UNITED STATES PATENT AND TRADEMARK OFFICE

APPLICATION NO.	FILING DATE	FIRST NAMED INVENTOR	ATTORNEY DOCKET NO.	CONFIRMATION NO.
10/780,409	02/17/2004	Kyle Turner	10808/118	1293

Office Action Summary

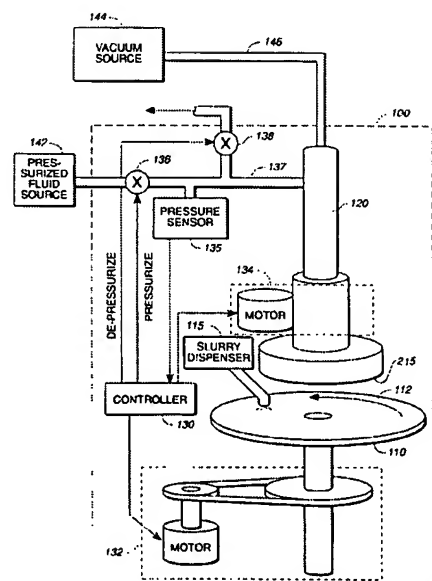
1. The drawings are objected to as failing to comply with 37 CFR 1.84(p)(4) because in Fig. 1, reference character "112" has been used to designate polishing pad instead of (111).

Corrected drawing sheets in compliance with 37 CFR 1.121(d) are required in reply to the Office action to avoid abandonment of the application. Any amended replacement drawing sheet should include all of the figures appearing on the immediate prior version of the sheet, even if only one figure is being amended. Each drawing sheet submitted after the filing date of an application must be labeled in the top margin as either "Replacement Sheet" or "New Sheet" pursuant to 37 CFR 1.121(d). If the changes are not accepted by the examiner, the applicant will be notified and informed of any required corrective action in the next Office action. The objection to the drawings will not be held in abeyance.
